Access Compliance Report

Public Rights-of-Way

Intersection ID: 29721	Main Street: COLE_MILL_RD	Cross Street: LANNIER_FALLS_LN	Location: NE
ADA ID: 01255D3EDD9C	Ramp Type: BlendTrans1	Initial Pass/Fail: Fail	Overall Compliance: No
		Severity Score: 8.75

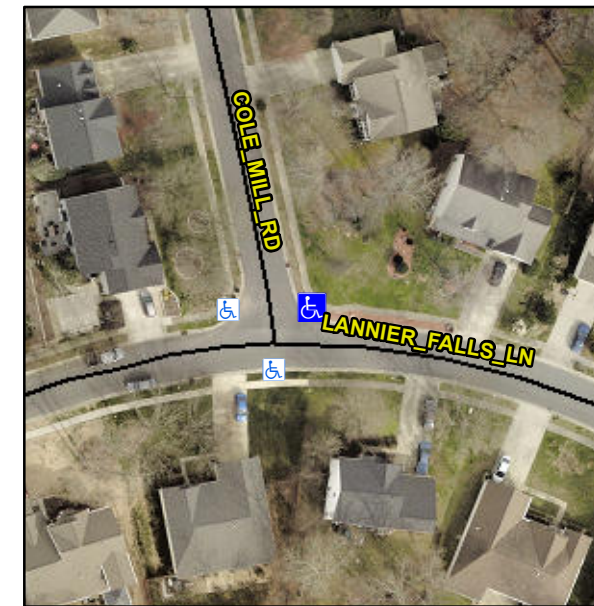
R304.5.1

Remove & Replace Curb Ramp With Two New Directional Ramps or Equivalent.
